Cronulla High School – 31 Bate Bay Road, Greenhills Beach

Statement of Environmental Effects for
Development Application

13 February 2023

Figure 8: Demolition plan, showing trees to be removed (Source: Fulton Trotter Architects)

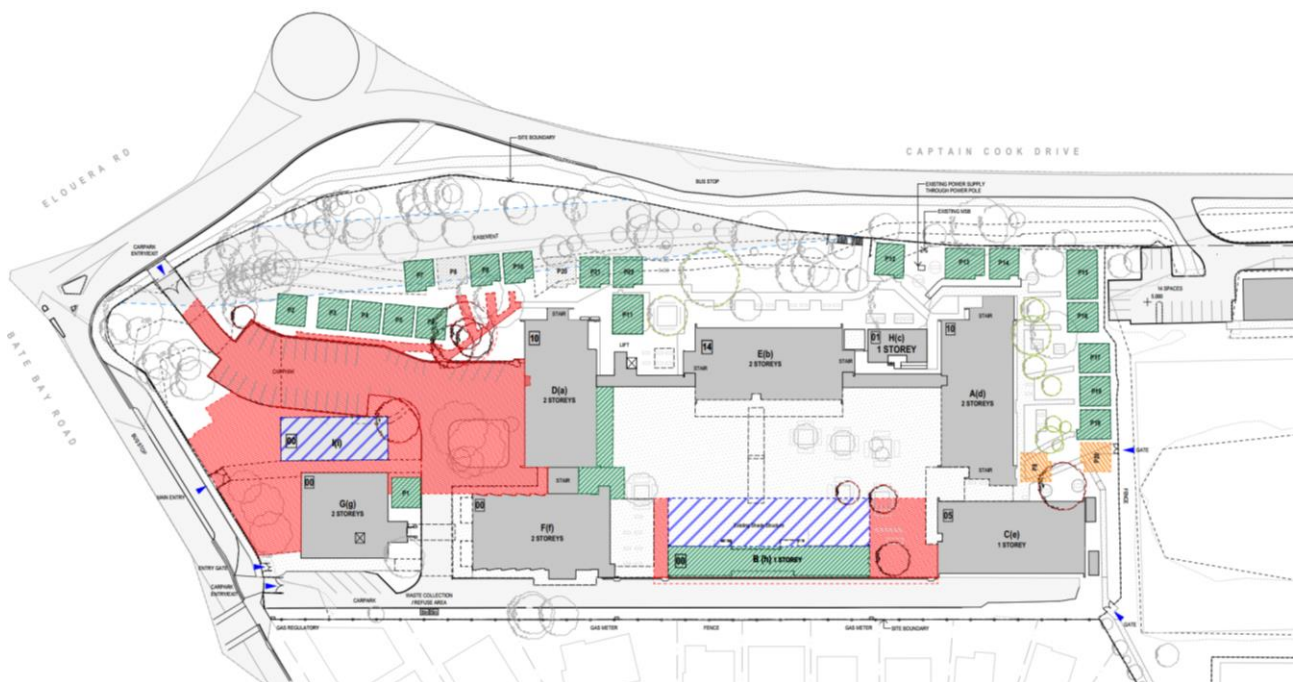
<p>i. Removal of trees 77 – 85 in the northern part of the site to assist with the relocation of demountable buildings (...)</p> <p><i>Recommendation: Remove Tree 85 (Angophora floribunda) as it is overmature and displaying signs of decline to site the extra demountable classrooms. Approve selective pruning of Trees 81, 82, 83, 84, 86, 113 to site demountable classrooms as required and directed by the appointed Project Arborist.</i></p>	<p>Consistent with Council's recommendations, the revised scheme seeks to removed Tree T85 and retain Trees T77-T84 with the implementation of appropriate tree protection measures.</p> <p>Selective pruning is proposed to Trees T81-T84, T86, and T113, as required.</p>
<p>ii. The proposal seeks to remove Trees 65, 69 & 70 which are a part of a west facing stand of endemic trees to site the substation. Trees 65 & 69 have a SRZ of 2.7m and Tree 70 a SRZ of 1.8m as the trees sit elevated on an embankment. Council would expect their tension roots to be extending upslope and have more bulbous roots at the base on the western side. Council understands that the substation must be located outside of the 'flood area' hence why it is not proposed flush on the boundary.</p> <p><i>Recommendation: As the substation is proposed to be constructed on the western and low side of the trees' SRZ, Council believes they should be retained. Council does not anticipate that it will be likely that excavation for the substation will encounter woody, structural and tension roots as these are expected to be headed up slope. The trees will still have ample room for transpiration and the uptake of water and nutrients. Council</i></p>	<p>Consistent with Council's recommendations, the revised scheme seeks to retain Trees T65, T69 and T70 with the implementation of appropriate tree protection measures.</p> <p>The new substation, and associated tree removal, is being pursued via a separate approval pathway in accordance with clause 2.44 of the Transport and Infrastructure SEPP.</p> <p>As indicated in the attached Arboricultural Impact Assessment, Trees T65 and T70 may be removed under this separate approval pathway. Notwithstanding, efforts have been made to minimise impacts on trees from the new substation.</p>

- iii. *The proposal seeks to remove Tree 72 (Eucalyptus microcorys) & Tree 73 (Arucaria heterophylla) due to the relocation of a demountable classroom.*

- iv. *The proposal seeks to remove T108 (Eucalyptus microcorys) and T109 (Melaleuca quinquenervia) both high value trees which should be retained. The demountable classrooms west of these trees are being removed as well as the concrete footpaths which intersect their TPZs. Works proposed around these trees are as follows, new Building L proposes a slab on ground with piers east of T108 and a newly aligned footpath. Note that existing building D remains unchanged.*

- v. *Trees 104-107 exist wholly within the development footprint and should be removed and tree replacement with a ratio of 4:1 planted on the site.*

vii. *There is discrepancy between the Landscape and Architectural plans intention to retain high value endemic trees 110, 111, 112 Casuarina glauca. The new entry way to the school grounds off Bate Bay Rd is proposed to be cut by up to 800mm and is where these trees exist currently.*

viii. *The proposal seeks to remove T103, a Norfolk Island Pine (...) It suffers a large incursion into the TPZ and clashes with proposed works on new Building L. Significant architectural redesign would be required to retain this tree conscious of it potentially becoming far larger.*

ix. *The proposal seeks to remove T87, T88 and T114 all *Cupaniopsis anacardioides* 'Tuckeroo'. To retain T87 and T114 the proposal would require substantial architectural redesign, these trees are better replaced onsite.*

Consistent with Council's recommendations, the revised scheme seeks to retain Trees T72 and T73 with the implementation of appropriate tree protection measures.

Consistent with Council's recommendations, the revised scheme seeks to retain Trees T108 and T109 with the implementation of appropriate tree protection measures.

The proposal maintains the removal of Trees T107-107. 48 replacement trees (4.8:1 ratio) will be provided to offset the proposed tree removal, as illustrated in the attached Landscape Plan.

Consistent with Council's recommendations, the revised scheme seeks to retain Trees T110-T112 with the implementation of appropriate tree protection measures.

The attached Demolition Plan has been revised to reflect the proposed tree retention.

The proposal seeks to remove Tree T103. Due to the constrained location to accommodate new buildings on-site (i.e. Building L) and the functional requirements of the school, it cannot be retained.

The proposal seeks to removes Trees T87, T88, and T114. Due to the constrained location to accommodate new buildings on-site (i.e. Building M) and the functional requirements of the school, they cannot be retained.
